Product Change Notification

109314 - 00

Change Notification #: 109314 - 00
Change Title: Intel 10 Gigabit XF SR Server Adapter (Bellefontaine OEM generic/Retail), Intel 10 Gigabit XF LR Server Adapter (Bellefontaine Retail LR), Intel 10 Gigabit XF SR Dual Port Server Adapter (Green Fountain OEM generic/Retail) & Intel 10 Gigabit AF DA Dual Port Server Adapter (Long Cove OEM generic/Retail)

New Clamshell, New Box and Remove the ESD (Electrostatic Discharge) Static Bag

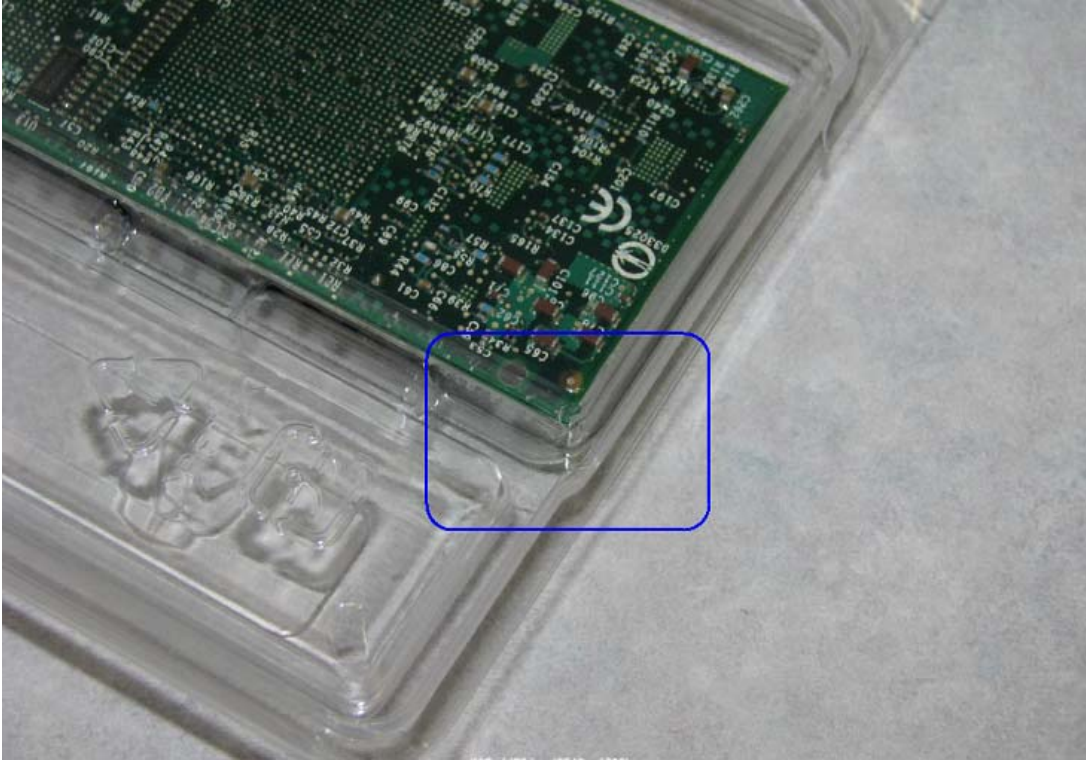
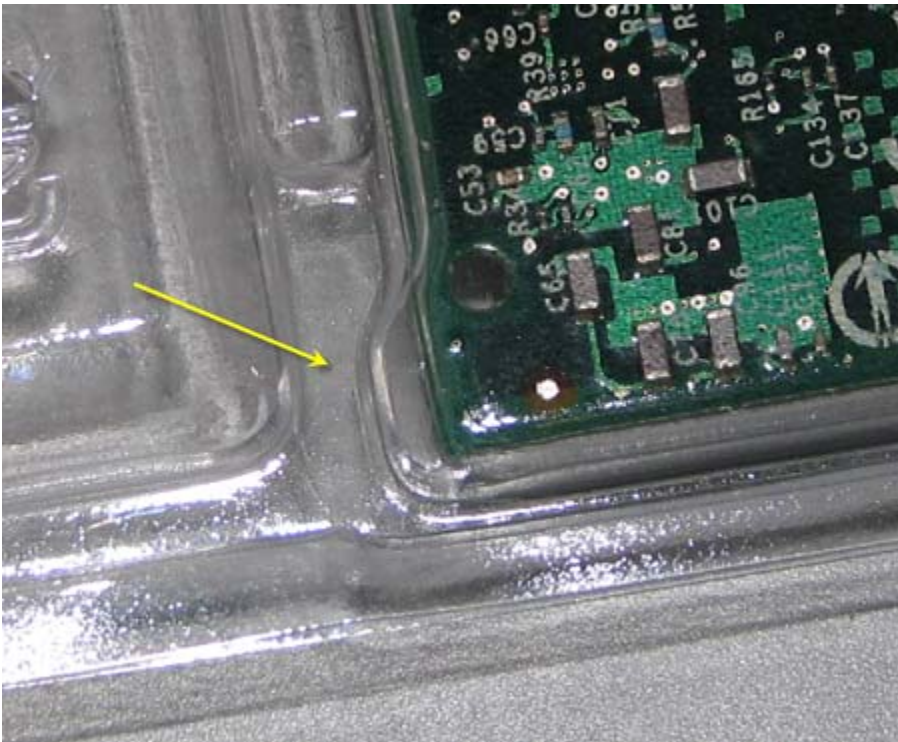
Clamshell Change:

Intel has modified the clamshell on our heavier Networking Adapters by adding a relief "bubble" area where the corner of the boards were poking a hole through the clamshell during the packaging drop test.

Intel has performed extensive drop testing on the modified clamshell without reproducing the same issue.

As noted by the before and after pictures below.

Old Clamshell, PCB corner poke showing damaged corner of the clamshell.

New Clamshell, added a bubble relief where PCB corner can't poke through at the corner of the clamshell.

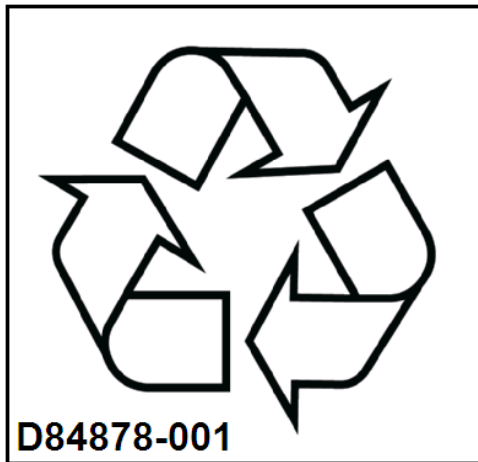
Cardboard Recycle Logo Label Change:

Intel will remove the cardboard recycle Label from all shipping boxes and replace with a pre-printed version on the box. This will eliminate the need for extra labels to be placed on boxes at our manufacturing facilities. A picture of this recycle label is shown below.
